MONTEREY COUNTY PLANNING COMMISSION

Meeting: December 13, 2006 Time: AM/PM	Agenda Item No.: 7
Project Description: Consider recommended changes to a Combined Development Permit consisting of: Coastal Administrative Permit and Design Approval to demolish an existing 2,704 square foot single family residence and 426 square foot garage (3,130 square feet total), construct a new 5,167 square foot, 3-level single family residence with a 1,498 square foot subterranean garage, grading (400 cubic yards cut); Variance to reduce the front setback from 20 feet to 15 feet along Scenic Road; Variance to reduce the front setback from 20 feet to three feet along a private easement; Variance to increase height limit from 18 feet to 18.63 feet; and Coastal Development Permit to allow development within 750 feet of an archaeological site. The property is located at 26195 Scenic Road, Carmel (Assessor's Parcel Number 009-422-023-000), Coastal Zone.

Project Location: 26195 Scenic Road, Carmel	APN: 009-422-023-000
Planning File Number: PLN040581	Owner: Nancy M. Moellentine Applicants: Lon & Morley Moellentine Agent: Lombardo & Gilles
Plan Area: Carmel Area Land Use Plan	Flagged and staked: Yes
Zoning

Figure 1 - Site Plan

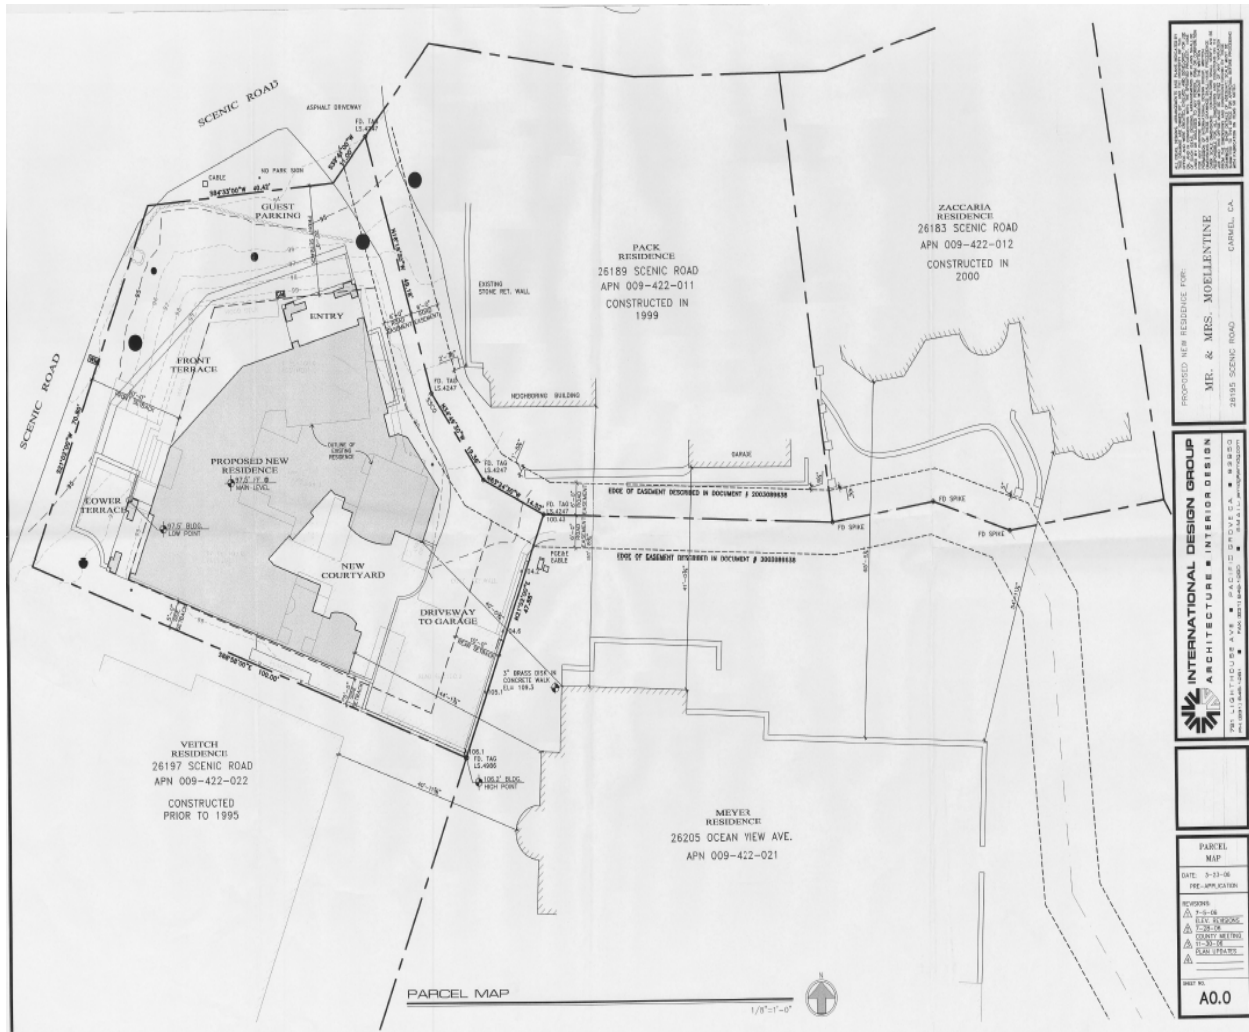
A 12-foot wide, private road easement is located along the east side, with the property line located at the center of the easement. By definition, this creates two sides that are required to meet the front set back standards (*See Figure 1-Site Plan*). The property line intersecting with Scenic Road would be considered a side yard and the property line intersecting with the easement would be considered the rear yard.

The property fronts on Scenic Road, which constitutes a front property line. In addition, there is an existing 12-foot wide driveway easement encumbering the eastern six feet of the subject property (Moellentine) and six feet encumbering western six feet the neighboring property (McCallister, Parcel 011). Staff interprets that the subject property has two front set backs, the property line intersecting with Scenic Road would be considered a side yard, and the property line intersecting with the easement would be considered the rear yard.

2. Front (Easement). Staff interprets that when an easement (public or private) provides access to multiple properties, it is a right-of-way that is subject to front yard set back requirements. The required minimum set back from the edge of the easement right of way is 20 feet. As designed, the residence would have less than a set back of 2-foot, 10-inches (8'-10" from the property line located at the center of the easement). In order to provide required light and ventilation for the lower level, the architect has included a light-well located 1-foot from the edge of the easement (7 feet from the property line). It is not clear on the plans, but it appears that the garage, which is below grade, would be located approximately 1-foot from the edge of the easement.

Analysis provided above shows that using the 50% rule (Section 20.62.040.F) would not support an exception to the proposed set back of 1-foot. However, that analysis also shows that precedence has been set that allows a reduction of the set back required for a minimum of 3 feet 6 inches measured to the edge of easement (9 feet 6 inches from the property line) for homes along this easement.

The main/upper levels are set back 23 feet from the rear property line, and lower level (garage) is 20 feet. A retaining wall ranging from 15-19 feet tall would be constructed along the entire rear property in order to gain access to the lower level parking garage. This wall continues along the side yard and is attached to the house. Fences/walls over six feet in height are considered to be a structure.

- 1) Scenic Road Set Back. The set back from Scenic Road is critical to retain the visual integrity of this viewshed. Staff recommends that all living areas maintain the minimum front set back of 20 feet, including the living area located below grade. As a result, the light-well would be set back 10 feet allowing a more reasonable planting area to soften this elevation.

- 2) Easement Set Back. Staff finds that some set back from the easement should be granted. A 3-foot 6-inch set back would be consistent with the property located opposite the easement from the subject site. The edge of the light-well should be set back at least three feet to again allow reasonable planting area to soften this elevation.
